MODIFICATION REQUIRED FOR A/T APPLICATIONS, ONLY WITH v 1.0 HARNESS

FTI-STP1: Vehicle Coverage and Preparation Notes

FTI-STP1: Installation and Configuration Notes

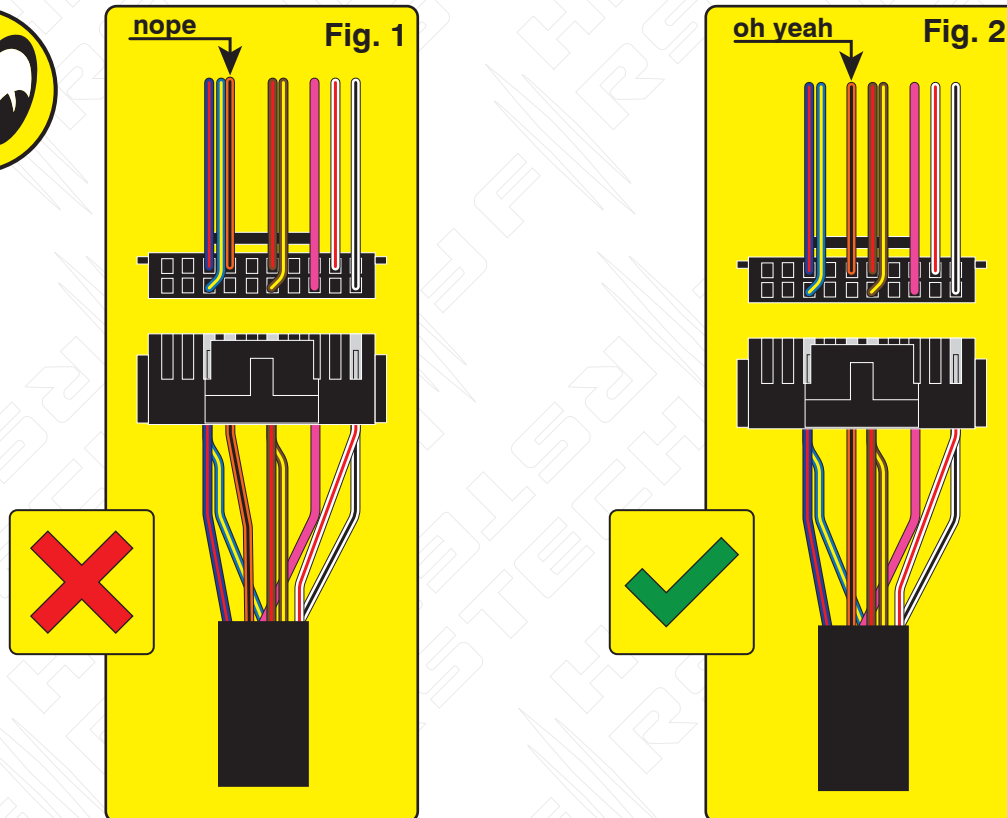
Overview: Production error in version 1.0 harnesses; The immobilizer wire (orange/black) is in pin position #4 instead of pin position #5. Although an effort to correct the issue was made, some quantity of harnesses did get shipped before the issue was spotted. We are advising to inspect the harness BLADE connector before attempting to install harness or program the module. This issue is not known to affect the version 2 harnesses, which require no modification.

Issue: Module fails to program correctly to vehicle, does not allow the vehicle to be remote started.

Correction: Step 1.) Locate the orange/black wire and confirm whether it is positioned as illustrated in Fig. 1 or Fig. 2. If the wire is as illustrated in Fig.1, proceed with Step 2 through 5 and complete the repair procedure outlined, if the wire is as illustrated in Fig. 2, correction is not necessary, proceed with harness installation and module programming.

Step 2.) Using a pick, lightly depress the catch that secures the terminal in the housing then remove the wire and terminal from the housing.

Step 3.) Using a fine tip razor or utility knife, insert the blade beneath the terminal catch and raise it slightly, so that it can be reused to secure the terminal when reinserted into the BLADE connector housing.

Step 4.) Refer to Fig. 2 for correct position of the orange/black wire (next to brown/red) then reinsert the terminal, pressing lightly until the catch 'snaps' into place, securing the terminal in the connector housing.

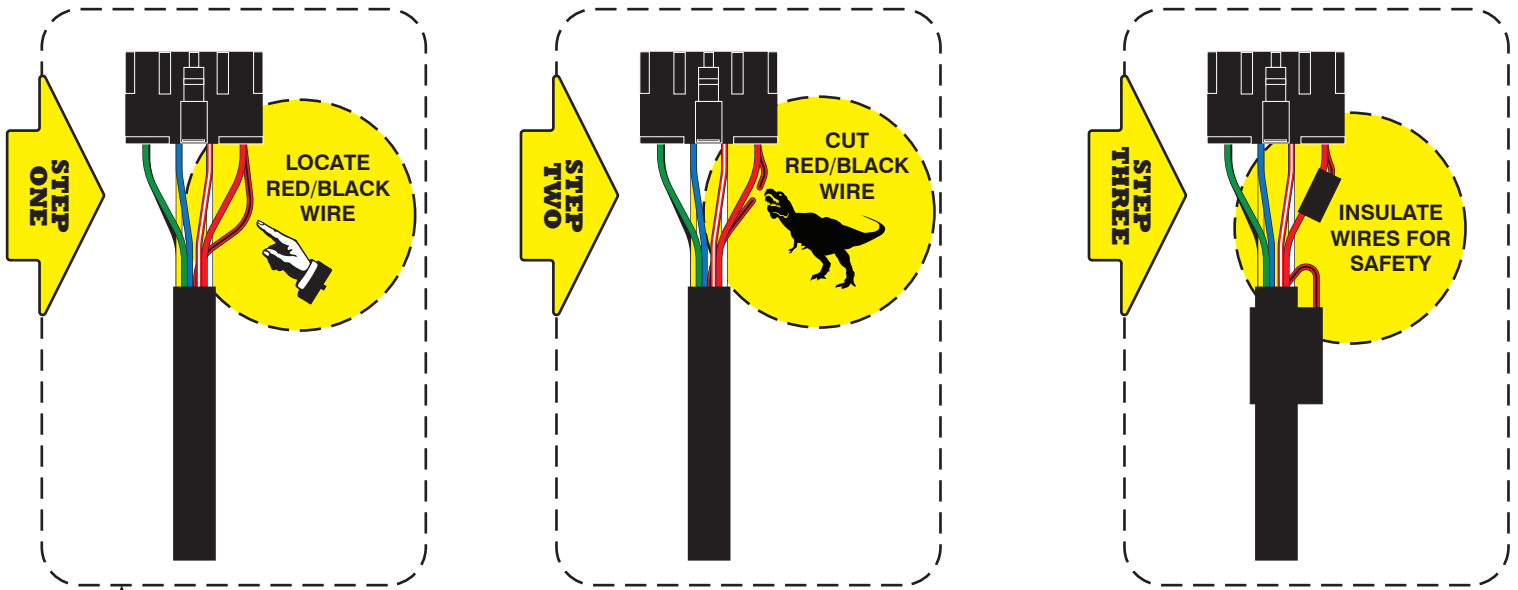
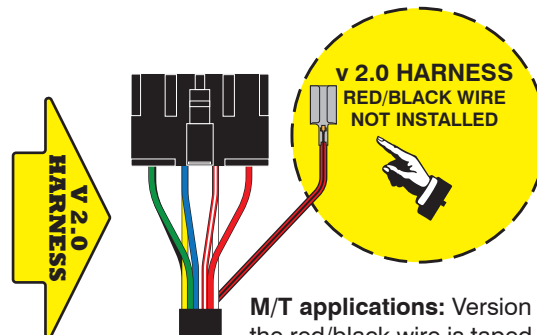
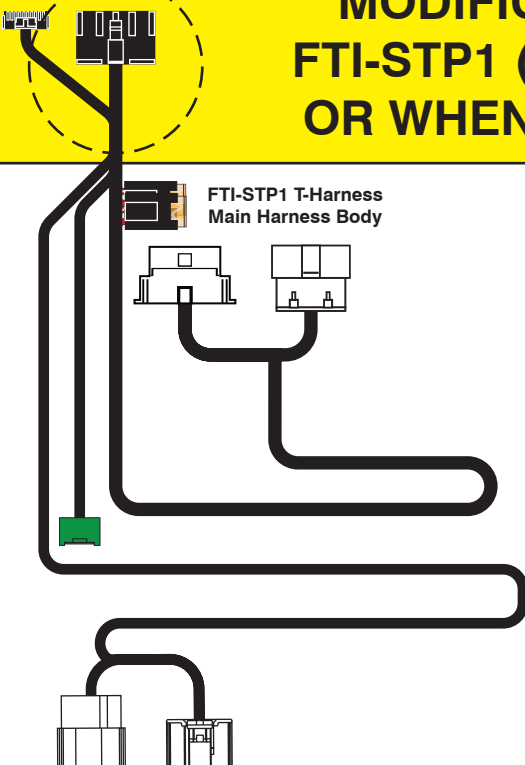
Overview: Early versions of the FTI-STP1 harness require modification for **automatic transmission (AT)** applications, some of the product was able to be modified before release, but a small quantity was released without modification.

Issue: The FTI-STP1 T-harness has been designed to be compatible with A/T (automatic transmission) & M/T (manual transmission) applications, but due to an oversight in early production runs, the selection was defaulted to M/T mode.

Using a harness configured for an M/T application, in an A/T equipped vehicle, could result in vehicle module damage, it is advised that the harness be returned to A/T mode before installation in vehicles equipped with an automatic transmission.

Correction: Locate the **red/black (+ Clutch)** wire provided in the CN1 connector of the main harness assembly. Cut the **red/black** wire, either flush to the CN1 connector, or leaving enough wire exposed so that you can insulate and secure the ends of the wire that remain after cutting. Insulate each of the remaining ends of the **red/black** wire and secure to prevent any possibility of a short circuit. **If the red/black wire has already been disconnected, no further modification is required for A/T applications**

M/T applications: Version 2.0 harness, the red/black wire is taped to the main harness when shipped, and must be installed in the CN1 connector when installed.

A/T applications: Leave the red/black wire taped to the harness, it is not required for A/T applications
